# UNITED STATES PATENT AND TRADEMARK OFFICE

APPLICATION NO.	FILING DATE	FIRST NAMED INVENTOR	ATTORNEY DOCKET NO.	CONFIRMATION NO.
10/712,269	11/14/2003	Vernon R. Brethour	28549-198910	7955
26694	7590	07/22/2005	EXAMINER	
VENABLE LLP P.O. BOX 34385 WASHINGTON, DC 20045-9998				DEPPE, BETSY LEE
		ART UNIT		PAPER NUMBER
		2637

<b>Office Action Summary</b>	<b>Application No.</b>	<b>Applicant(s)</b>	
	10/712,269	BRETHOUR ET AL.	
	<b>Examiner</b>	<b>Art Unit</b>	
	Betsy L. Deppe	2637

**DETAILED ACTION**

FIG. 10

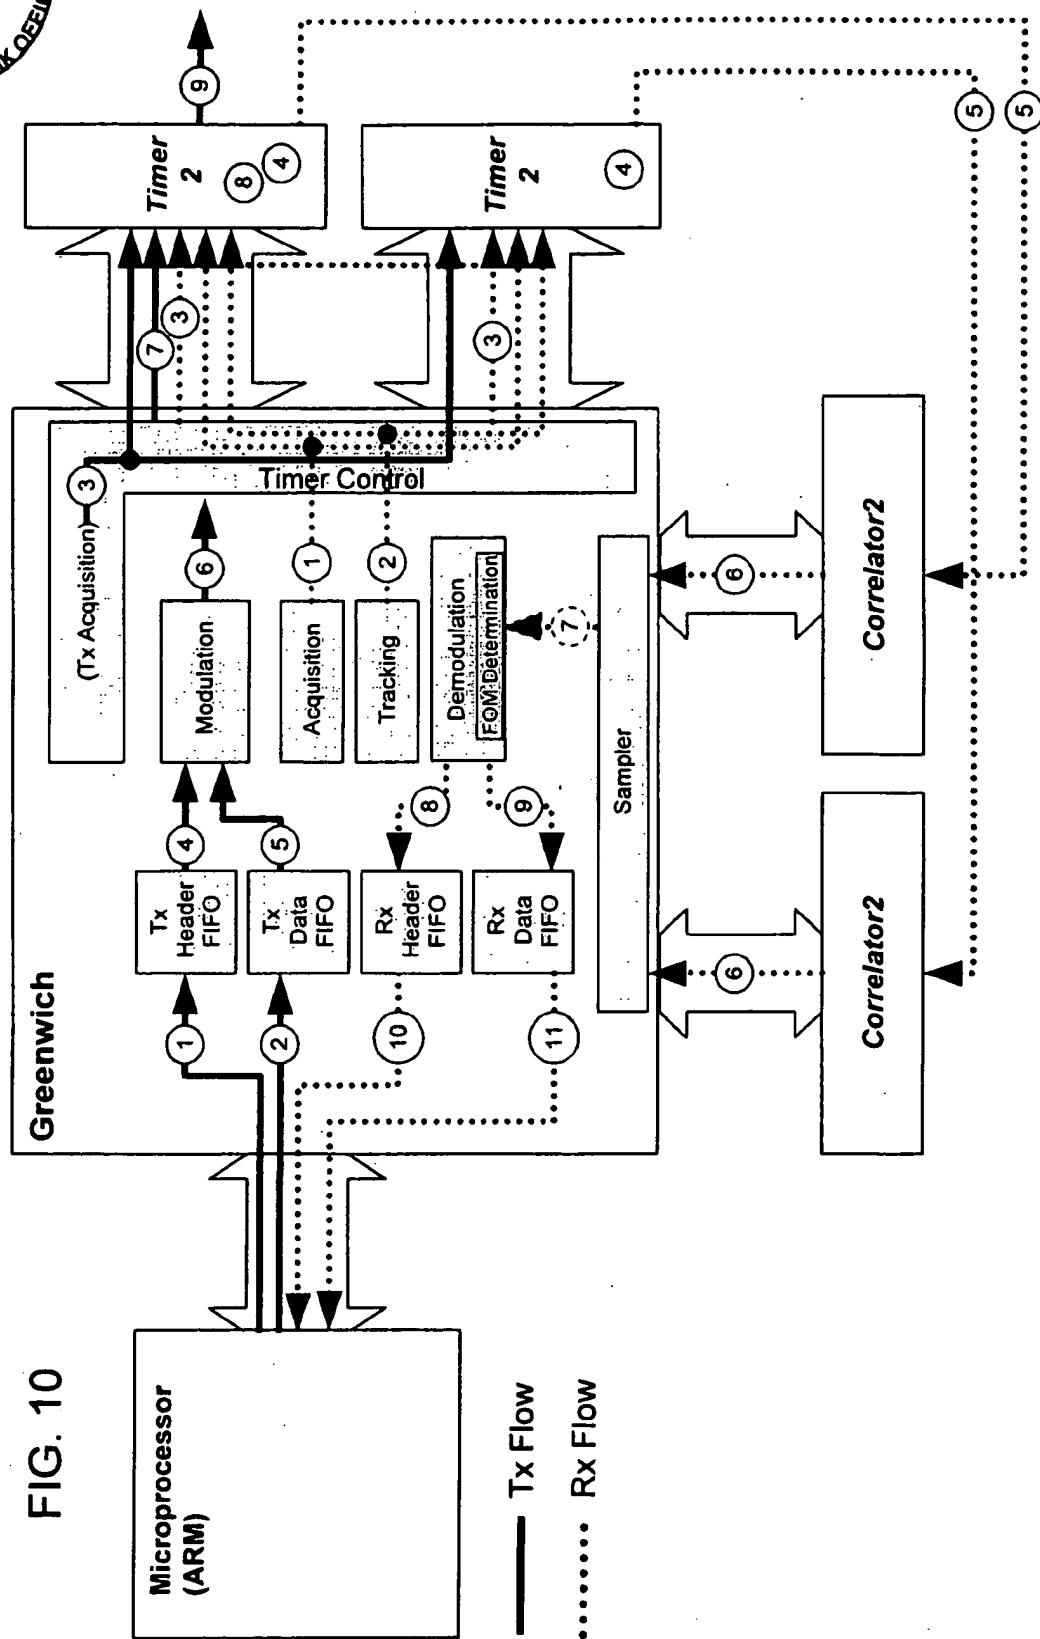
3. The drawings were received on May 13, 2005. These drawings are not accepted because it does not comply with 37 CFR 1.84(c) which requires the drawing sheet to be identified as a replacement sheet. Appropriate correction is required.

Not accepted
